To the Environment, Planning and Sustainable Development Directorate,

PTCBBR welcomes the opportunity to make a submission on the development applications for the proposed Woden Transport Interchange and associated works. We support the ACT Government's significant investment in public transport infrastructure and are pleased to see a project of this scope to replace the current interchange, which is tired and poorly configured.

Figure 5 - City West Bus Shelters

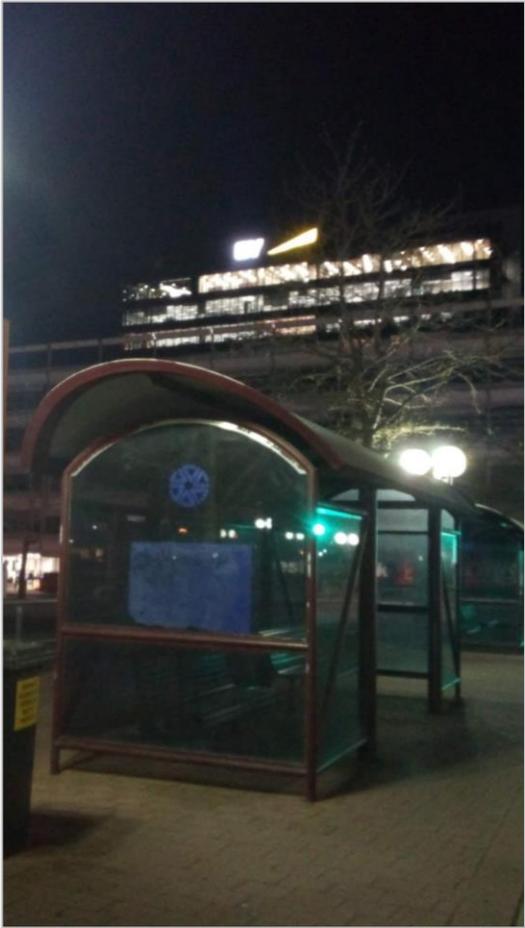
- extending a continuous back wall to all bus platforms, and not only the central light rail platforms,
- bays at the end of each platform with at least 270° shielding to protect from breezes, which were a feature of many Canberra bus shelters until the 1990s (see [Figure 5](#)),
- cafe-style infra-red heating, which is common in most outdoor dining areas these days, and
- a suitable seated waiting area within the future CIT complex, with appropriate passenger information to allow passengers enough time to walk to their platform.
